PROJECT: 23-26- Sequoyah Bus Parking
Bid Date 3-28-2023 at 3pm

PROJECT NO. 21330

Narrative For Addendum #1

DATE: 3-21-2023

DRAWN: AE
CHECKED: JP
JOB No. 21330
DATE: 03/03/2023
C700
SITE DETAILS

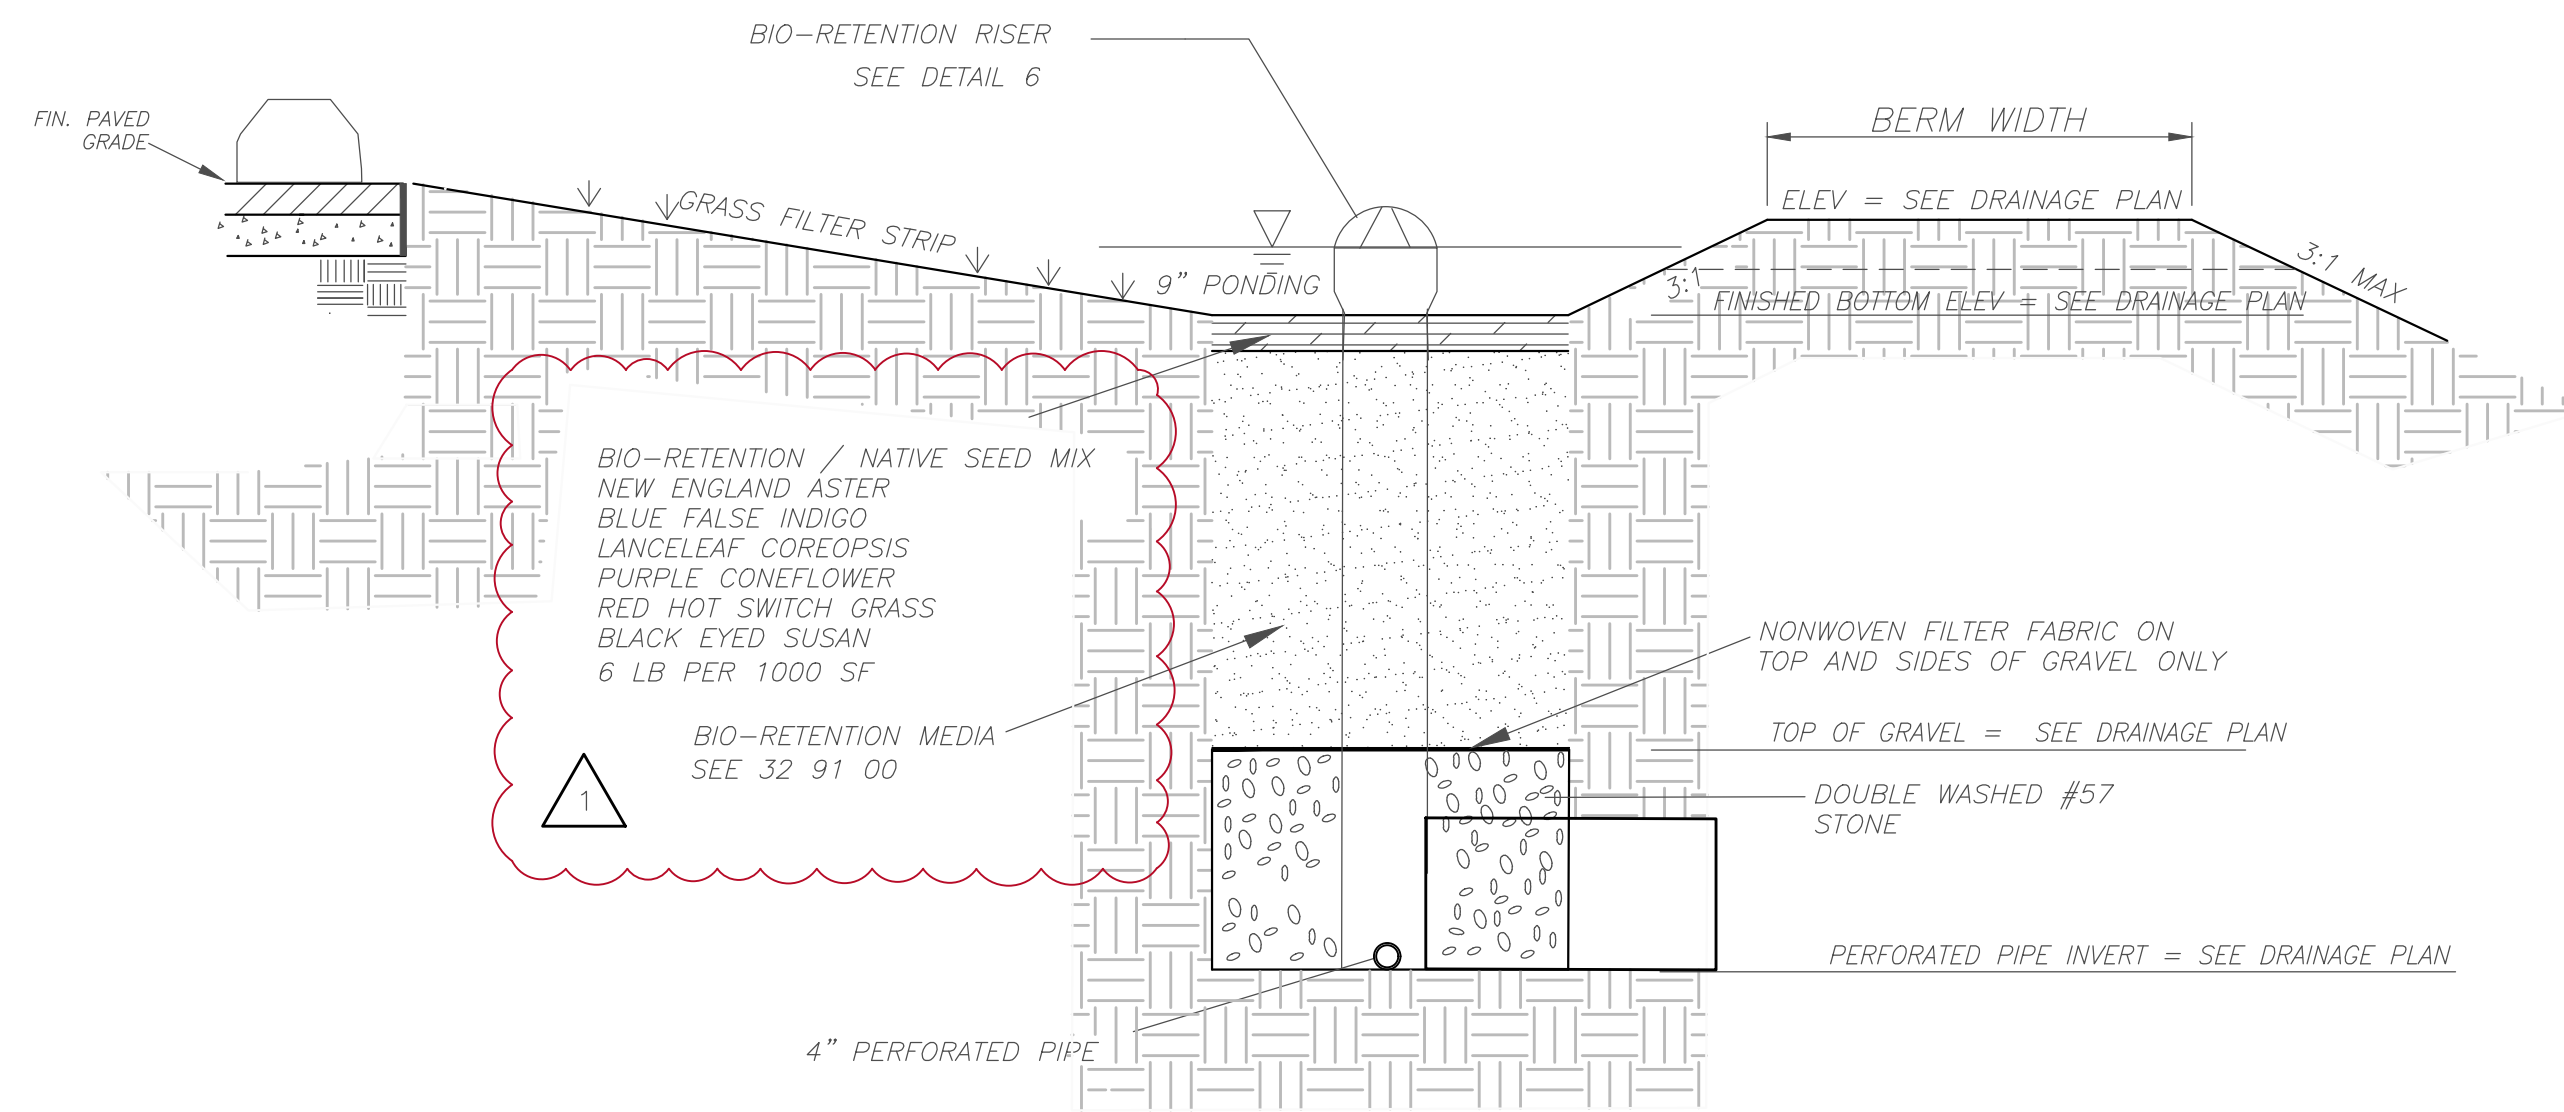
1. Revised asphalt to grass detail 13 to say pavement to grass
2. Revised 90-degree parking detail 1 to match plan view.
3. Added swinging bar gate detail 14
4. Added accessible parking symbol detail 15.
5. Added stop bar detail 16
6. Added painted traffic arrow detail 17
7. Listed chain link fence as 6 ft tall on detail 10.
8. Revised concrete pavement detail to use 6x6 WWF instead of rebar.

1
C800
DETAIL: BIO-RETENTION AREA
(NTS)

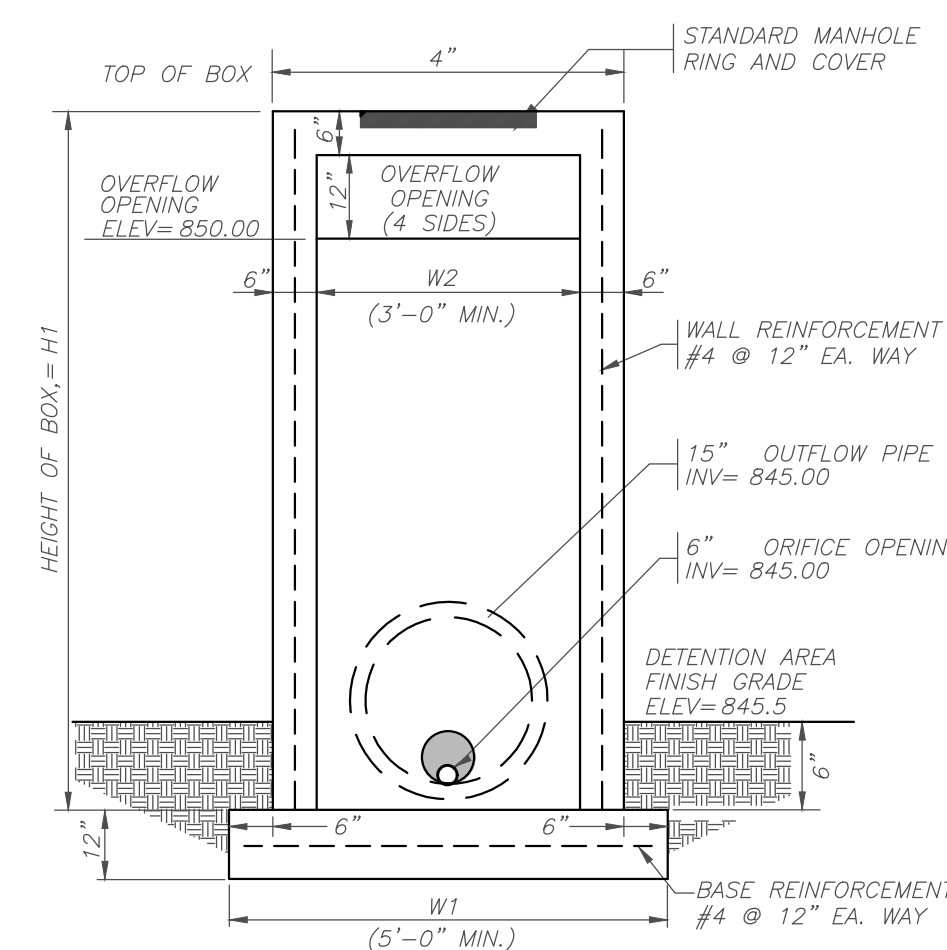
1. Revised Bioretention Area detail 1 to specify native seed mix, instead of mulch.
2. Added reference to bio-retention media specification in detail 1.

ES101

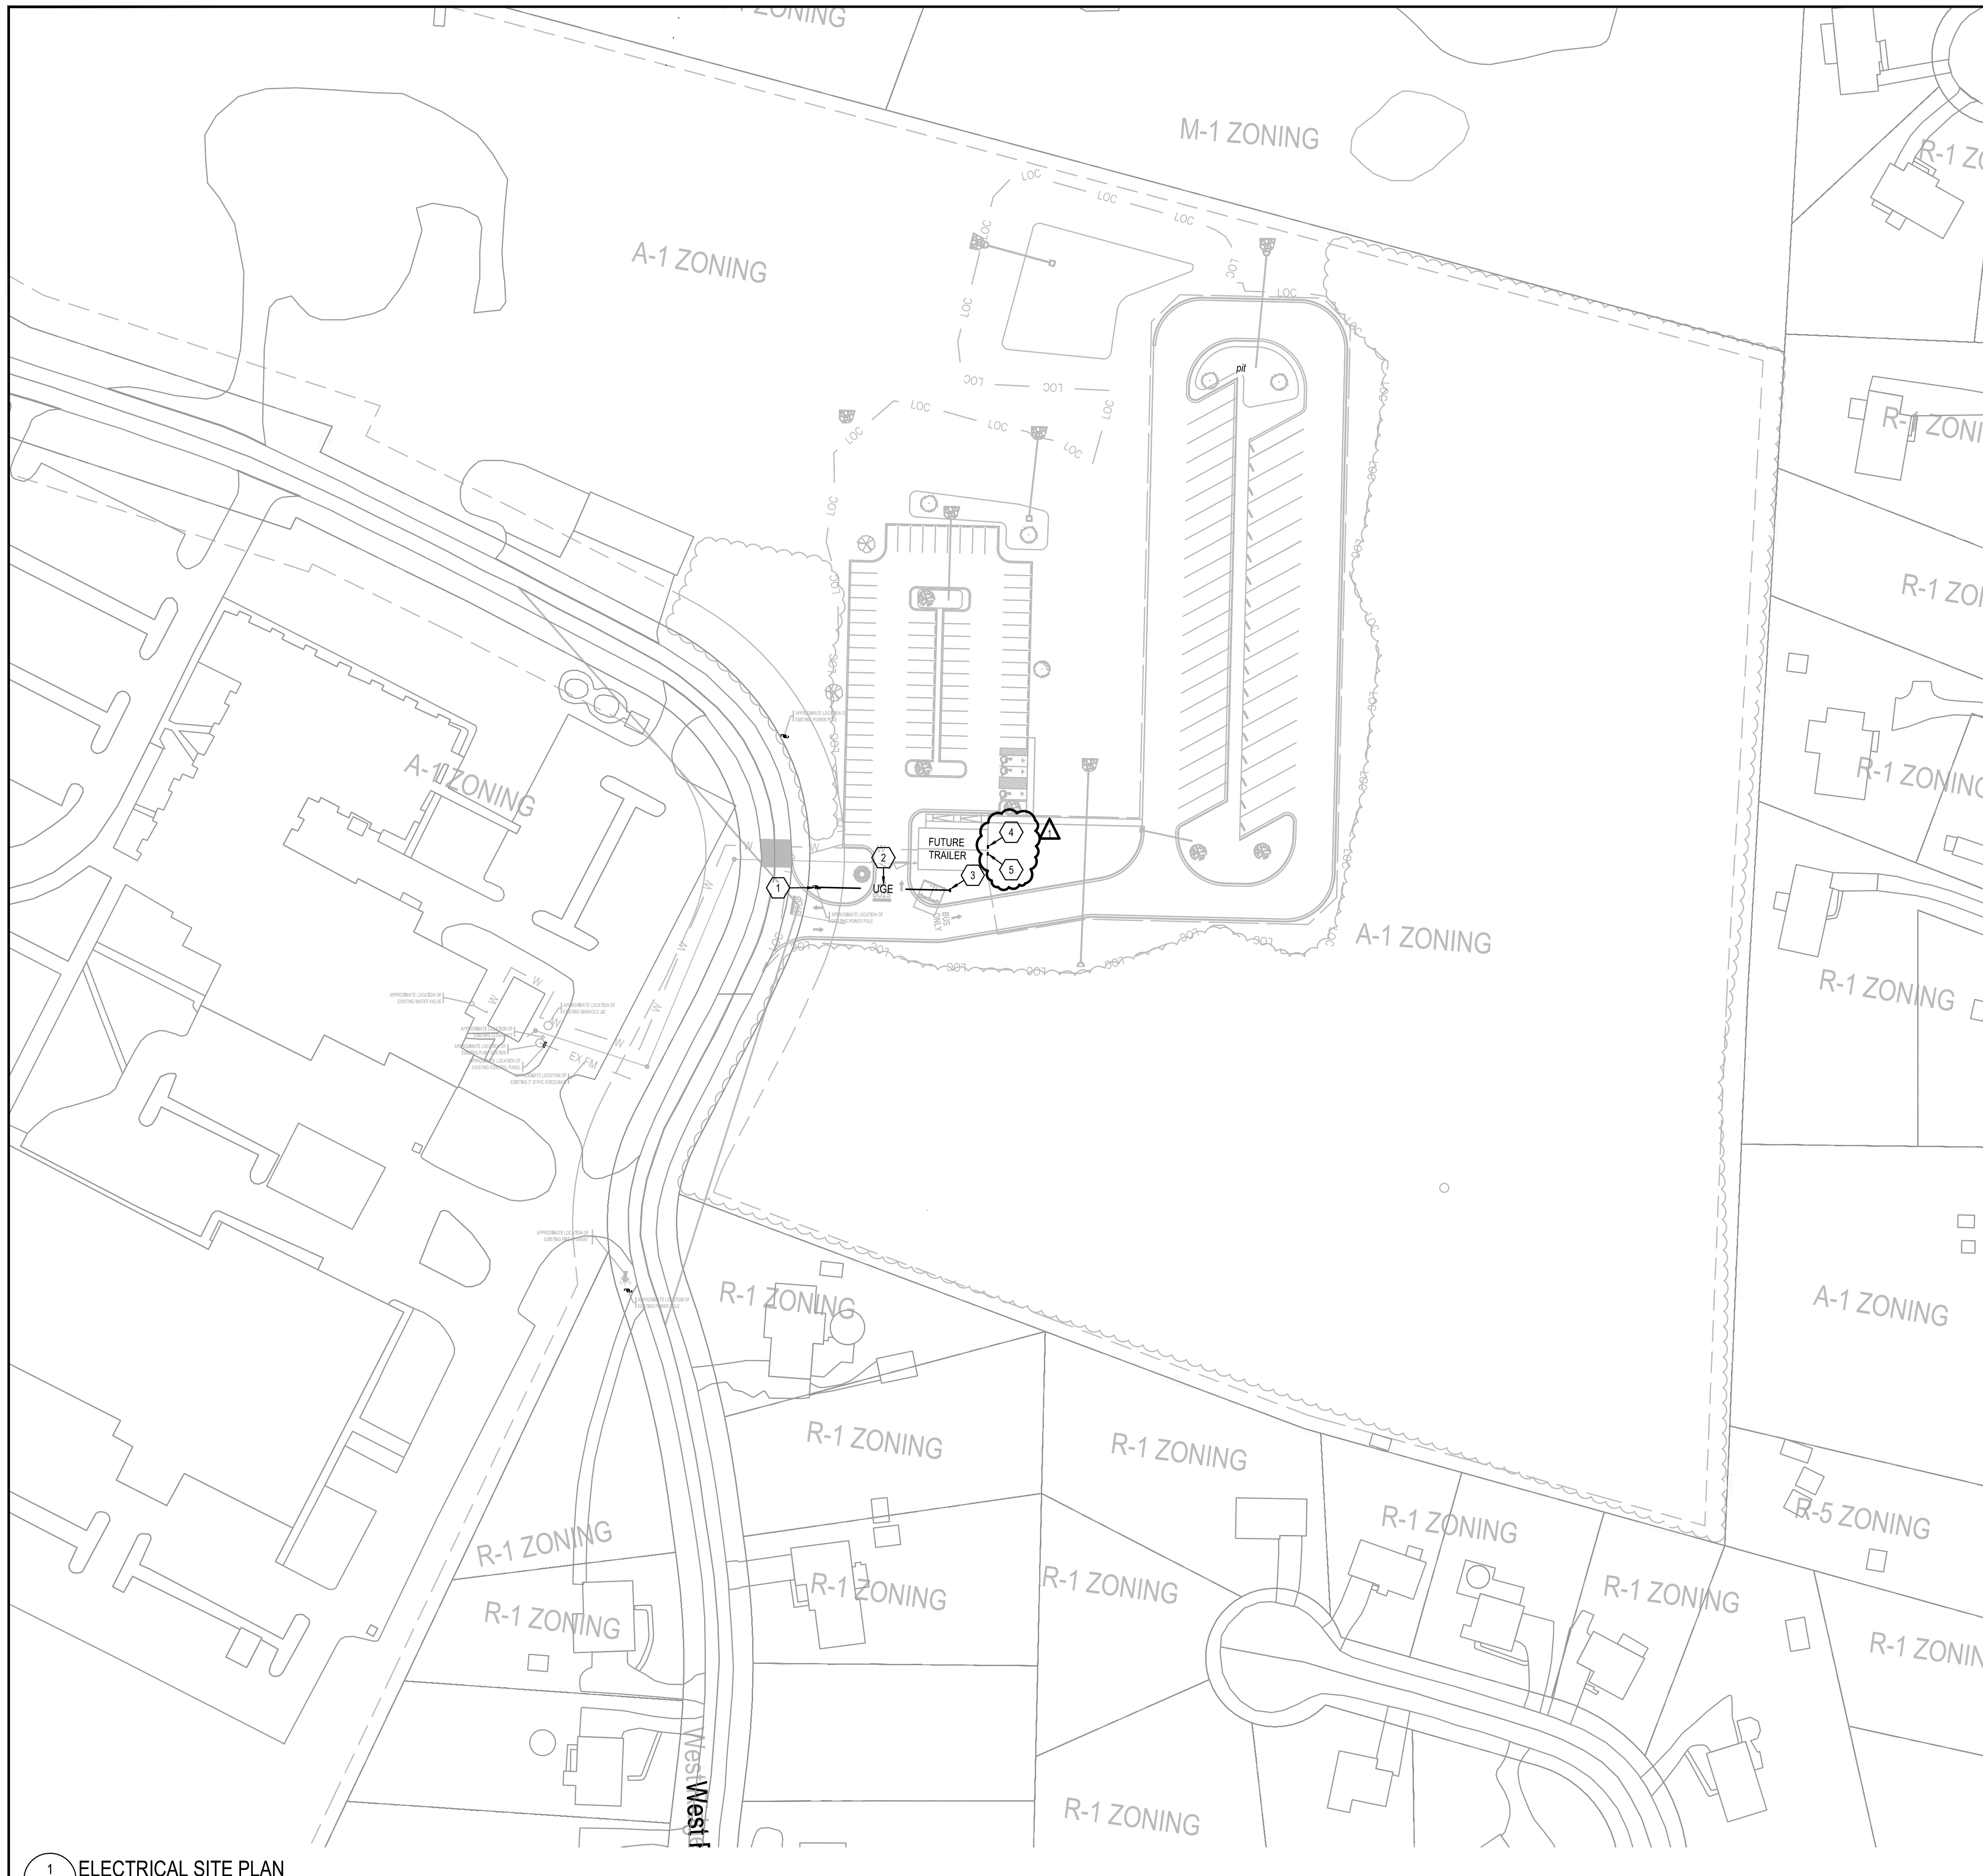
1. Revised to add power for trailer to be set by owner
